GROOT LETABA RIVER WATER DEVELOPMENT PROJECT (GLeWaP)

TECHNICAL STUDY MODULE: Preliminary Design of Nwamitwa Dam

VOLUME 6 Annexure 1: Appendices

Appendix I : Comments

STRAIGHT OGEE SPILLWAY
LAYOUT

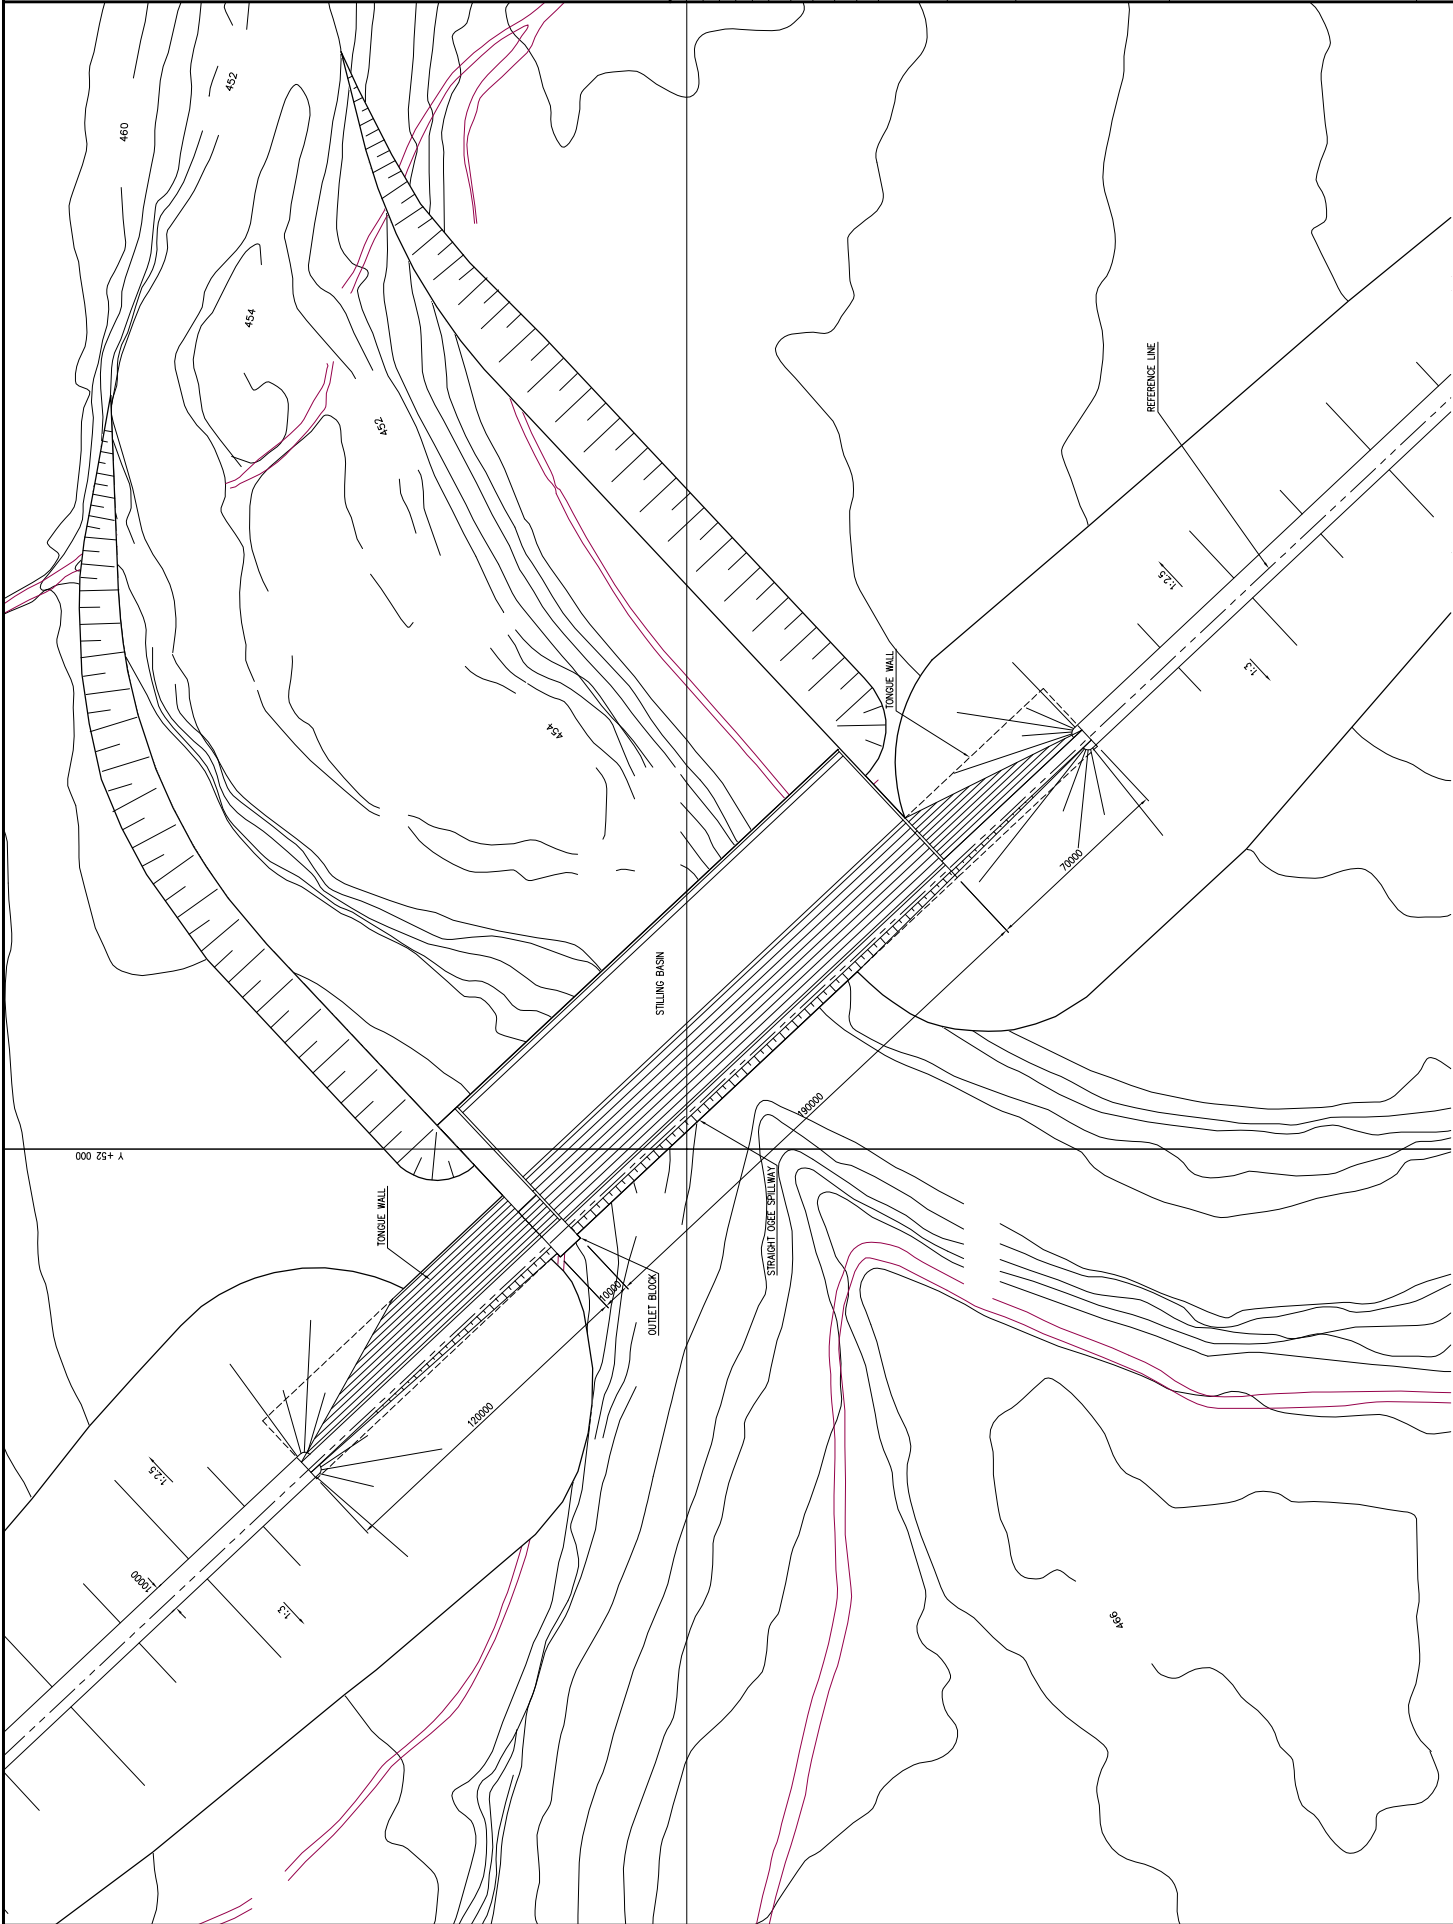
- *Par 7.3.4 : Stilling Basin :* A spillway apron length of 16 m is indicated, although the drawings in the "APPENDICES" show a length of about 35 m. This is contradictory. In addition : Modern RCC dams with stepped spillways which have been extensively tested with hydraulic models, are being built with apron lengths of less than 10 m.

- **Appendix C.2 : Straight Ogee Spillway** : No gallery shown. Contradicting with other cross-sections shown.
- **Appendix C.2 : Straight Ogee Spillway** : Refer comment above with regard to spillway apron length.
- **Appendix C.2 : Straight Ogee Spillway** : Refer comment above with regard to spillway u/s slope.
- **Appendix C.5 Nwamitwa Dam Freeboard**: Check/recalculate wind speed ratio's:

- Par 5.4 *Semantics – not incorporated in report*
- Par 5.5 *Detailed design*
- Par 7.3.4 *Reference to previous version of drawings*
- Par 9.1.2 *Changed reference to “the owner”*
- Par 11.5 *Inserted reference*
- Par 12 *Included construction programme*
- Conclusions / Recommendations *Added*
